DELEGATED REPORT

Application Reference: PL/2023/06302

The application is for the demolition of existing building and erection of 6 dwellings and associated works at Martins Transport, Linleys, Corsham.

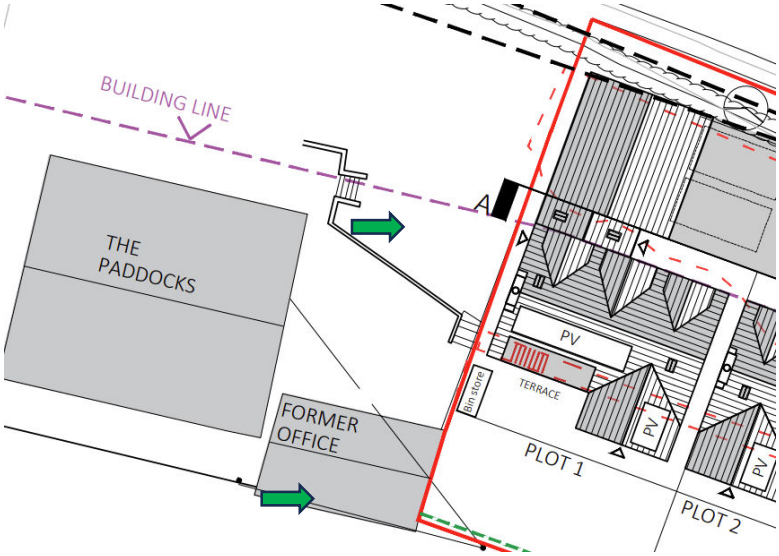
"*Previously noted anomalies (identified as Areas A & B within previous landscape consultation response) with regards to the red line application boundary and the former adjoining remnant land uses still need to be addressed, but these are technical planning matters, and no further landscape advice is necessary. The domestic curtilage of Plot 1, separating it from the Paddocks needs to be established, due to the proposed side access leading from Plot 1 to its rear garden area.*

Proposals are still not clear on whether the existing area of hardstanding outside of the application boundary, fronting Silver Street, will be removed and replaced with soft landscape as part of the works to extend the existing footpath along Silver St into the development. It would be very unattractive if it were left as hardstanding near the pedestrian and vehicular access to the new development. This area should be restored back to soft landscape/verge the details of which could be secured by condition.
